**Re: Galles and David Motor Company Hummer Addition and Remodel, 6401 San Mateo Blvd NE, Traffic Circulation Layout
Engineer's Stamp Dated 6-06-05 (F17-D63)**

Galles & Davis Motor Co.
Hummer Addition & Remodel
6401 San Mateo Blvd. NE
Albuquerque, NM 87109

OVERALL SITE PLAN

SITE PLAN

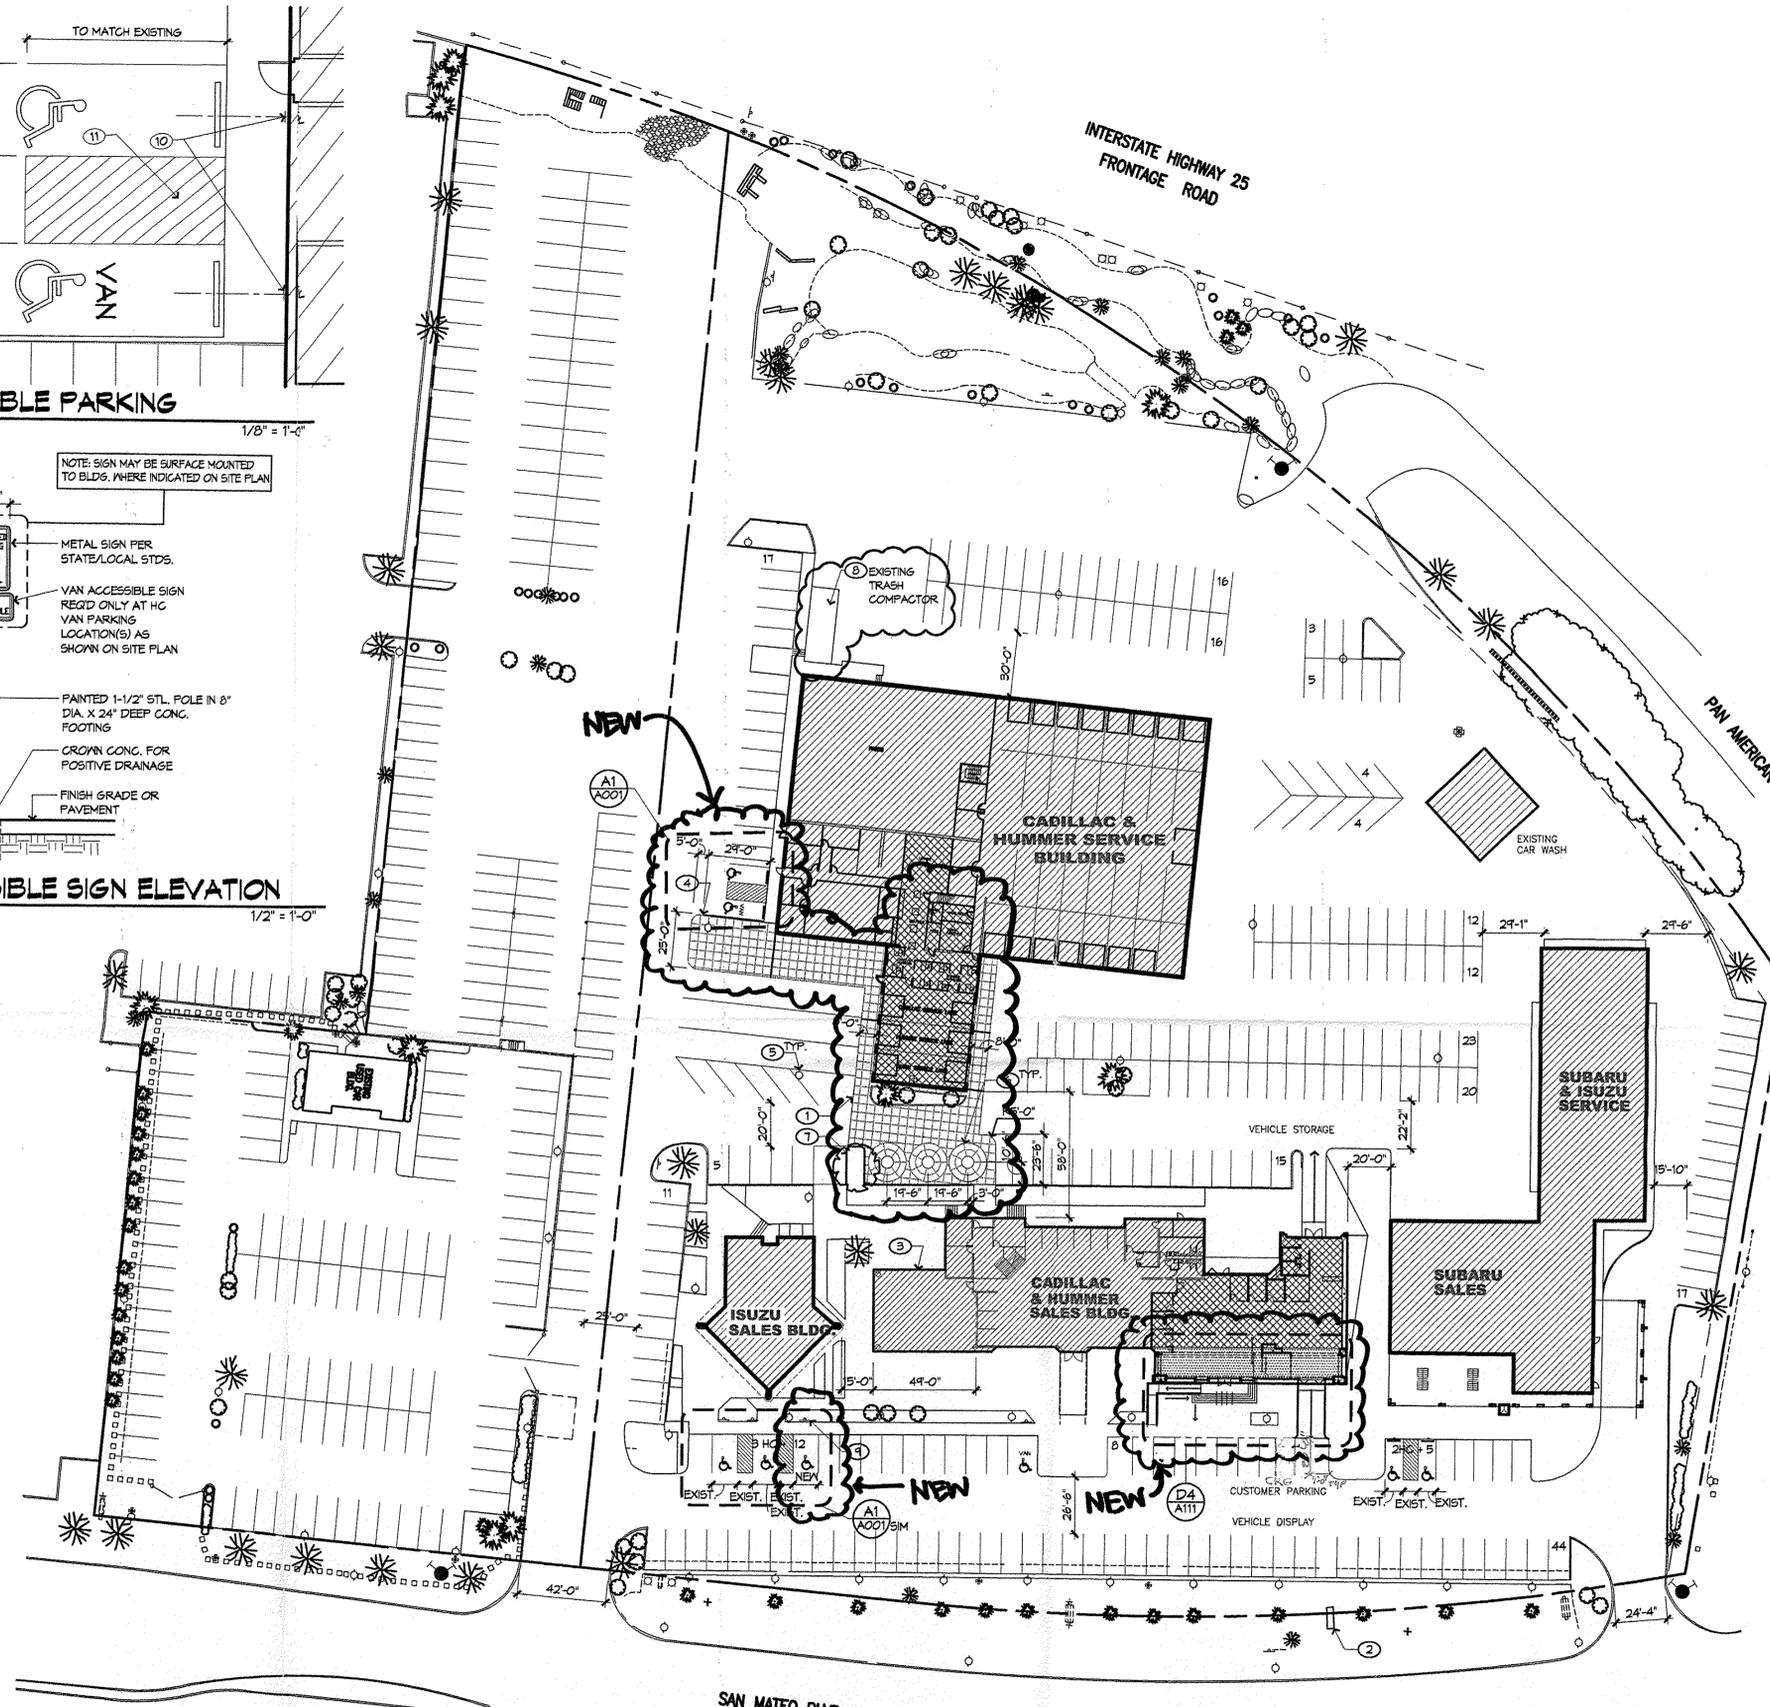
The TCL submittal received 7-14-05 is approved for Building Permit. The plan is stamped and signed as approved. A copy of this plan will be needed for each of the building permit plans. Please keep the original to be used for certification of the site for final C.O. for Transportation.

TRAFFIC CIRCULATION LAYOUT
APPROVED
PLAS 7/21/05
Signed Date

Public Infrastructure shown
only and not part of approval.
Separate DTC/Permit approval
and Work Order required.
